OPERATIONS SAFETY NOTICE

OSN GEN-09-40

Alert Service Letter

Document No. 159-027-00 Rev. 1

FIGURE 1

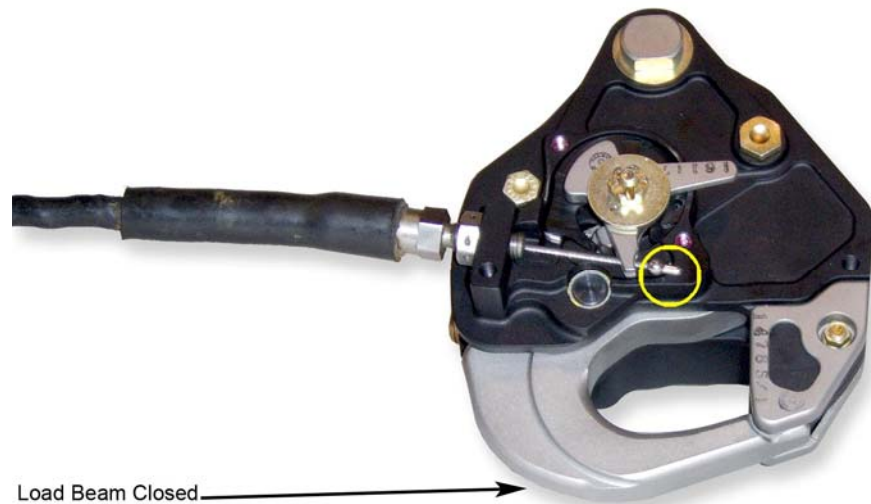
Picture of proper load beam position. The cargo hook load beam is fully closed and locked, ready to set the mechanical cable free play (circled in yellow).

It is critical that the load beam of the Onboard Systems TALON Keeperless style cargo hook is closed and fully locked before installation of the mechanical release cable and setting the cable free play. If the free play is set while the load beam is in the open position, when the load beam is closed it may reduce the amount of free play to an unsafe level that will not allow adequate margin of safety during external load operations. The reduced level of free play on the cable may result in inadvertently activating the release mechanism on the hook during operations, which could cause an inadvertent load release.

FIGURE 2

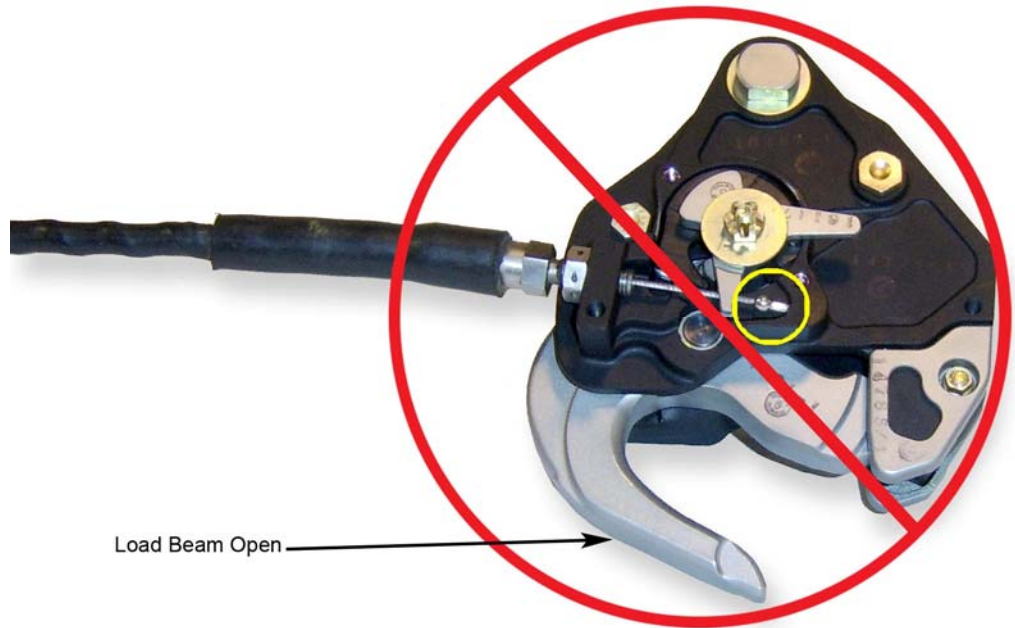
Picture of improper load beam position. The cargo hook load beam is open. If the mechanical cable free play is set now, there may not be enough free play in the cable (circled in yellow) when the hook is closed.
